Revised

RABBIT CREEK COVE SUBDIVISION

APPLICATION NUMBER Holdover DATE August 21, 2003

LOCATOR MAP

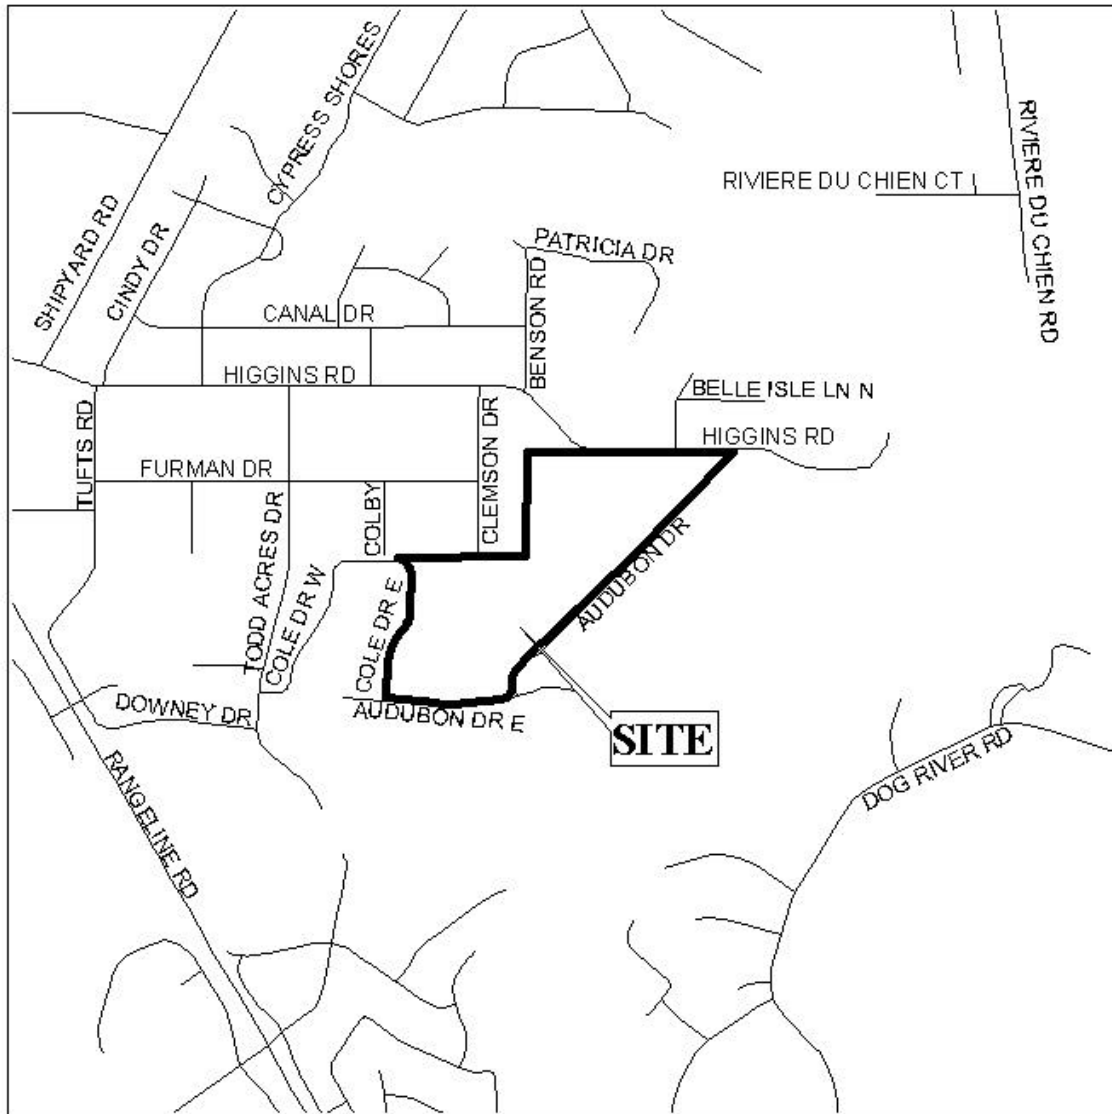
As illustrated on the Vicinity Map, the site adjoins an existing street stub—Clemson Drive. Section V.B.1. states “Existing streets that abut the subdivision shall be continued,” thus a connection with Clemson Drive should be provided. Additionally, the proposed cul de sac to the South of Clemson Drive exceeds the recommended maximum length of a closed-end street (Section V.B.6.); however, if the streets were connected, a waiver of Section V.B.6., would not be required. It should also be noted that the proposed cul de sac to the East of Clemson Drive would require a waiver of V.B.6. (closed end street).

Numerous lots are located on corners and the corner lots fronting existing streets should be limited to one curb cut to the new subdivision streets; specifically, Lots 57 and 60 should be denied direct access to Higgins Road, Lots 9 and 10 should be denied direct access to Audubon Drive, Lots 20 and 28 should be limited to one curb cut each to Audubon Drive, and Lots 31, 108, 110 and 128 should be denied direct access to Cole Drive.

With modifications and a waiver of Section V.B.1. for the cul de sac East of Clemson Drive, the plat will meet the minimum requirements of the Subdivision Regulations and is recommended for Tentative Approval subject to the following conditions: 1) provision of a connection with Clemson Drive; 2) that the use of all the common areas (detention, tot-lot etc.) be shown on the final plat, with a note stating that the maintenance thereof shall be the responsibility of the property owners; 3) the placement of note on the final plat stating that Lots 57 and 60 are denied direct access to Higgins Road, Lots 9 and 10 are denied direct access to Audubon Drive, Lots 20 and 28 are limited to one curb cut each to Audubon Drive, and Lots 31, 108, 110 and 128 are denied direct access to Cole Drive; and 4) approval of all applicable federal, state and local agencies.

DETAIL SITE PLAN

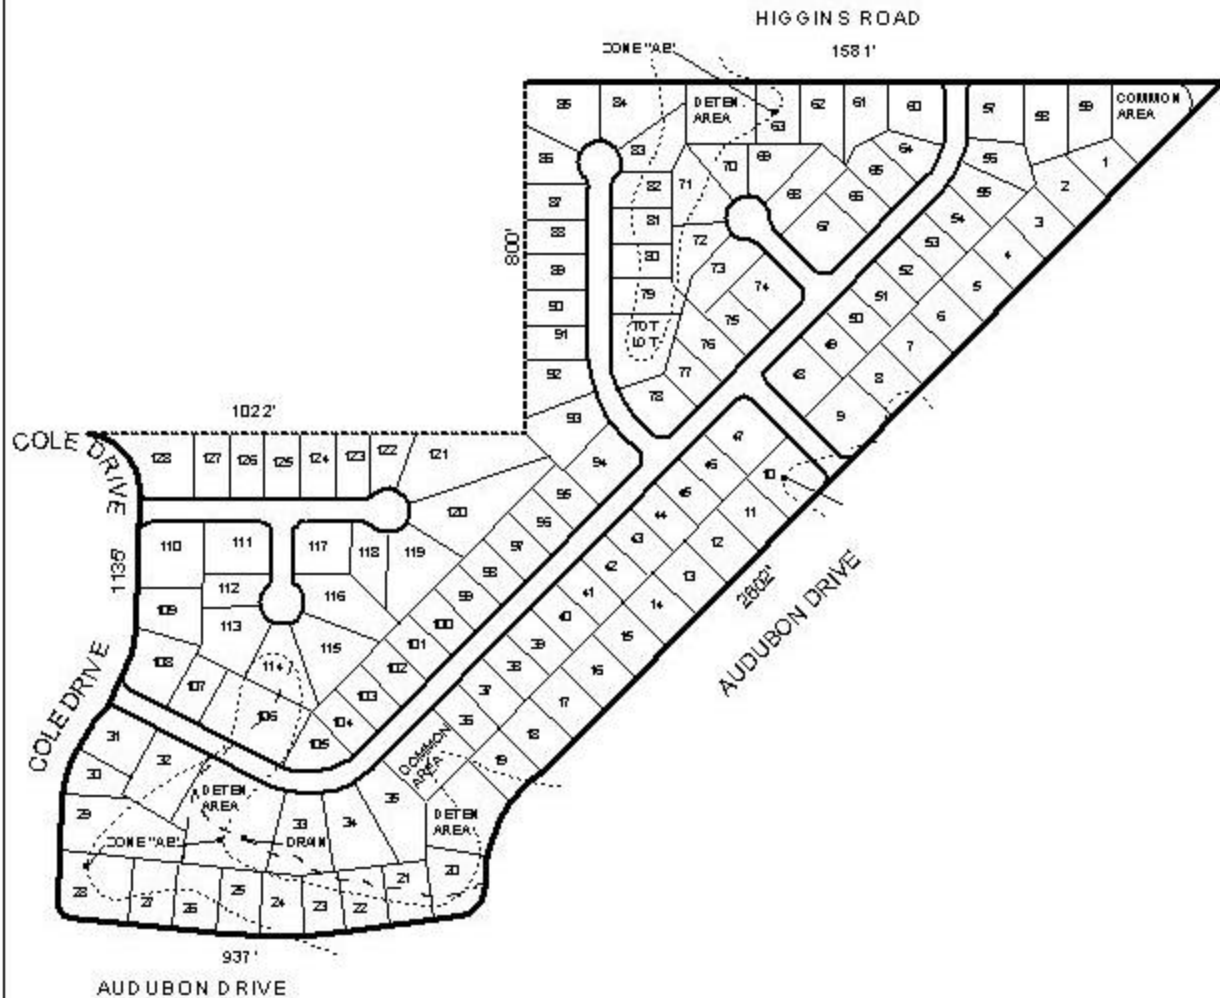
Illustrated on the plat are common areas, detention areas and a tot lot; the use of the areas should be reflected on the final plat with a note stating that the maintenance thereof shall be the responsibility of the property owners.
